## INFORMAL QUOTE PACKAGE 2020 PCC REPLACEMENT PROJECT

## PCC REPLACEMENT PROJECT

Revised May 20, 2020

## Re: City of Sparks 2020 PCC Replacement Project - Request for Quotes

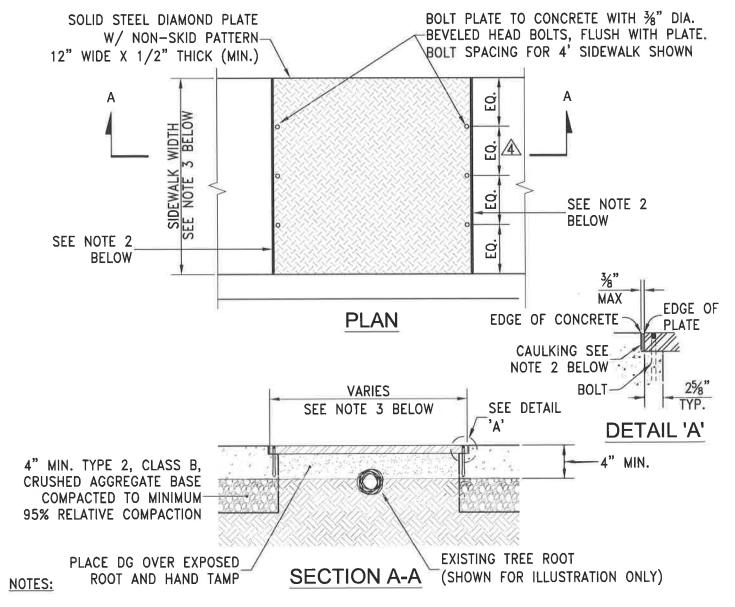
- 1. For Bid Item 1, the Certified Arborist will be required to look at all the locations identified on the locations spreadsheet for "Potential Root Mitigation". This is required due to the fact that some of these locations have been recently replaced and the roots have heaved the sidewalk again. I do not want to be doing this again so the arborist will be able to direct us on what roots could be modified or if a tree plate (Bld Item #2) is required.
- 2. Regarding Bid Item #2, This will be a last resort and only if the arborist and the City Assistant Public Works Manager agree that the tree plate is the only option. Should the tree plate be required, please see attached detail for the placement of the tree plate.

This email and the attached detail will be considered part of the Informal Quote sent out on Thursday, May 14, 2020 at 5:48 P.M. Please include this email and the attached detail in your submitted packet.

- 1. CONTRACTOR SHALL REMOVE <u>ONLY</u> THE EXISTING CONCRETE WITHIN THE ROOT MITIGATION LIMITS. THE CONTRACTOR SHALL EMPLOY AN ISA CERTIFIED ARBORIST TO PERFORM ROOT CROWN EXCAVATION ROOT PRUNING. ISA CERTIFIED ARBORIST SHALL COORDINATE THIS WORK WITH MARK ANDERSON, CITY OF SPARKS ASSISTANT PUBLIC WORKS MANAGER AT 775.353.2271.

- 2. SET PLATE FLUSH WITH ADJACENT CONCRETE AND PROVIDE 3/8" MAX GAP BETWEEN STEEL PLATE AND EDGE OF SIDEWALK. FILL GAP WITH CAULKING AFTER PLACEMENT OF PLATE. CAULKING MATERIAL SHALL BE GE SILICONE II\* W/D SUPREME, OR APPROVED EQUAL. COLOR SHALL BE WHITE.

- 3. ROOT PLATE WIDTH SHALL MATCH WIDTH OF SIDEWALK. ROOT PLATE LENGTH VARIES, FINAL LENGTH SHALL BE DETERMINED IN THE FIELD BY THE CERTIFIED ARBORIST AND ENGINEER.

- BOLTS: 3/8" DIA x 2 3/8" LONG DYNABOLT SLEEVE ANCHOR RAMSET REDHEAD FS-3826 OR APPROVED EQUAL. SIDEWALK WIDER THAN 4FT, BOLTS SHALL BE PLACED AT 18" O.C. FOR WIDTH OF SIDEWALK.

- 5. CONTRACTOR SHALL PROTECT TREES AT ALL TIMES, INCLUDING BUT NOT LIMITED TO TRUNKS, LIMBS AND ROOTS. CONTRACTOR SHALL BE RESPONSIBLE FOR ALL COSTS ASSOCIATED WITH REPAIR OR REMOVAL OF DAMAGED TREES DUE TO CONSTRUCTION ACTIVITIES.
